August 12, 2010

**Request for RF Register change – WMCU Firmware Version TP6 to TP7
(2010 Wireless DJ Turntable Controller – XBOX 360)**

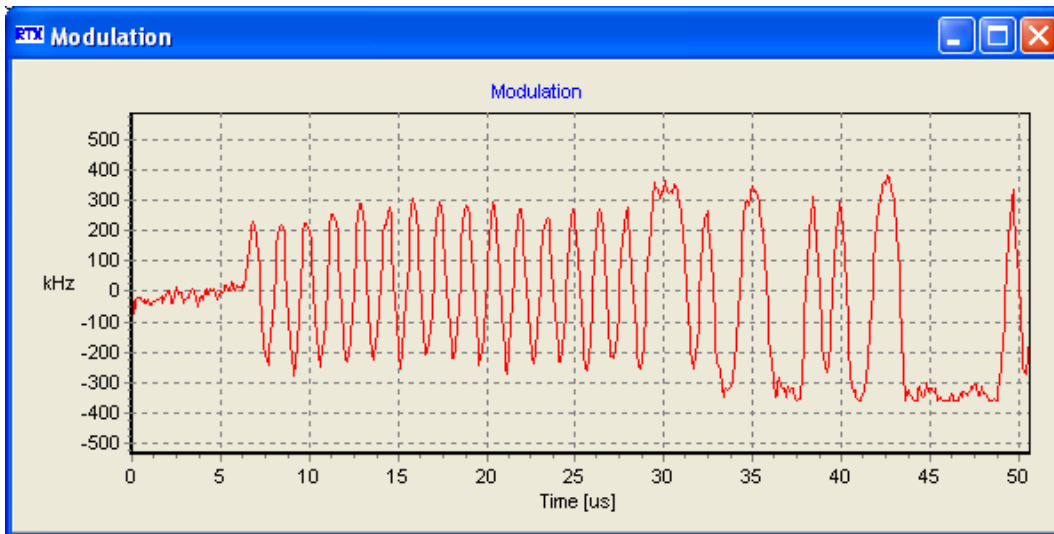
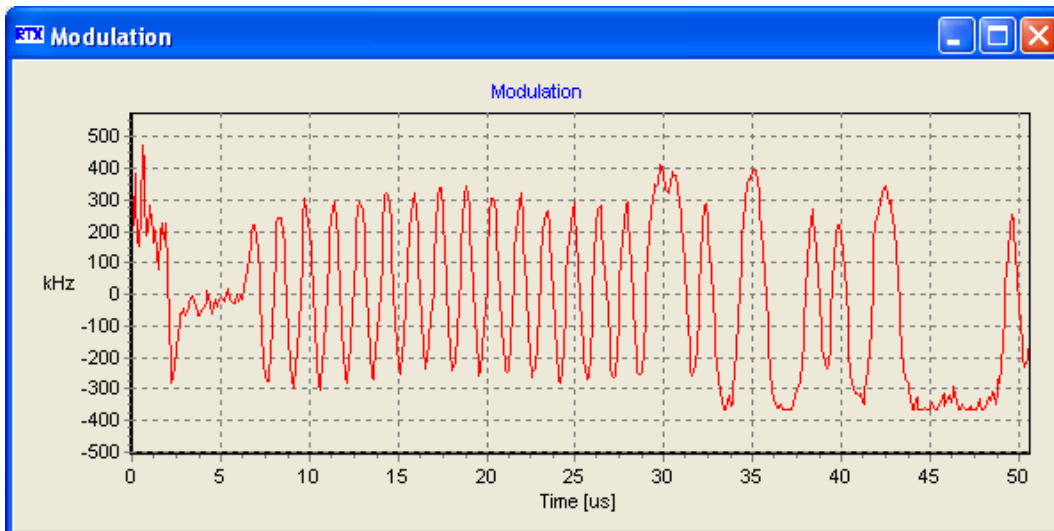
VCO stability improvement is made by turning on driver stage prior to PA turn on by 2.5us. Previously some frequency offset failures on production line were encountered due to open loop modulation format. Change compliance impact NIL was verified by band-edge analysis (see below).
